S E R V I C E N O T E

5DX Structural Process Test Systems Series I, II, 2L, 3

Modification to E-Chain Retainer Bracket.

Page 2 Service Note 5DX-61

Figure 1.

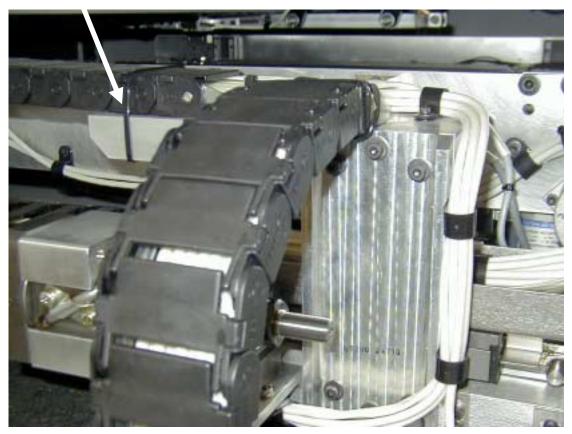
The tie wrap holding the E-Chain in position can break and the E-Chain starts hitting the Rear Laser during an XYZ Stage move. This unpredicted Stage movement can cause serious damage to the Rear Laser and/or the XYZ Stage, resulting in Galil1 Errors, XYZ Stage Errors, and/or Laser Surface Mapping Errors.

- 1. Perform Long Term Shutdown of 5DX.
- 2. Quit from Auto UI.
- 3. Using the mouse, double click on the 5DX Reset Icon.
- 4. In the original Auto UI Dos Window Type "exit".
- 5. Turn off the PDU.
- 6. Open the Rear and Top Left Access Panels to access the XYZ Stage.
- 7. Remove the Tie-Wrap from around the E-Chain if it is still there (see Figure 1).

Install the E-Chain Retainer Bracket Kit (P/N E7200-60204) using the following procedure (P/N E7200-90077-A). The E-Chain Retainer Bracket will prevent the E-Chain from hitting the Rear Laser Surface Map Assembly.

Figure 7.

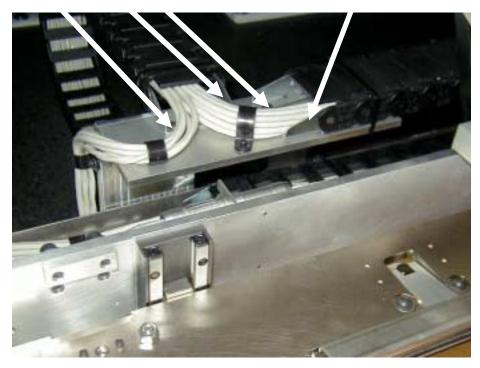
13. Mount both E-Chains to the new E-Chain Support, using the same 4 screws (see Figure 7).

Figure 8.

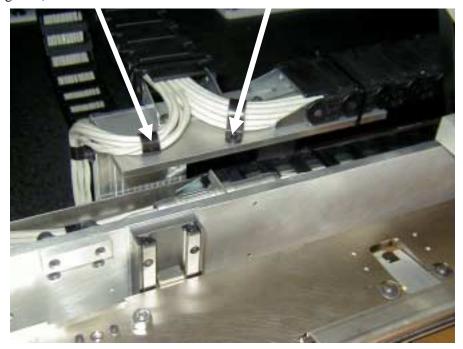
14. Mount both Cable Clamps to the new E-Chain Support, using the same 2 screws (see Figure 8).

Figure 9.

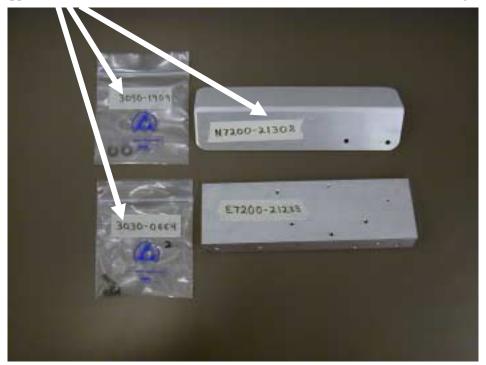
15. Mount the new E-Chain Bracket Cover (Part # N7200-21308) on top of the E-Chain, using the supplied 2 screws (Part # 3030-0664) and 2 washers (Part # 3050-1909) (see Figure 9).

Figure 10.

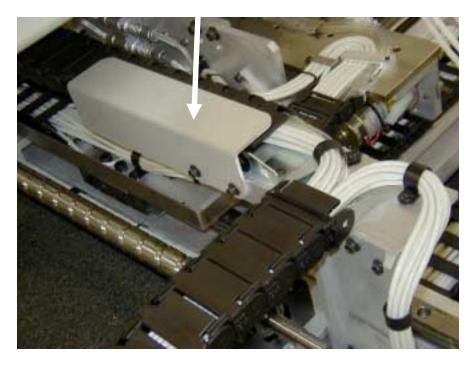
16. When finished, it should look like Figure 10.

Figure 11. Continued

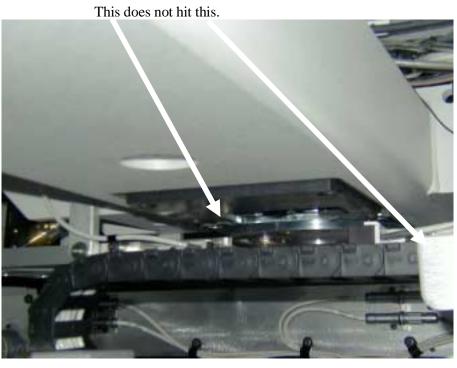
17. Move the XYZ Stage by hand so the E-Chain Bracket under the Rear Laser Assembly to insure it will not hit the Assembly.
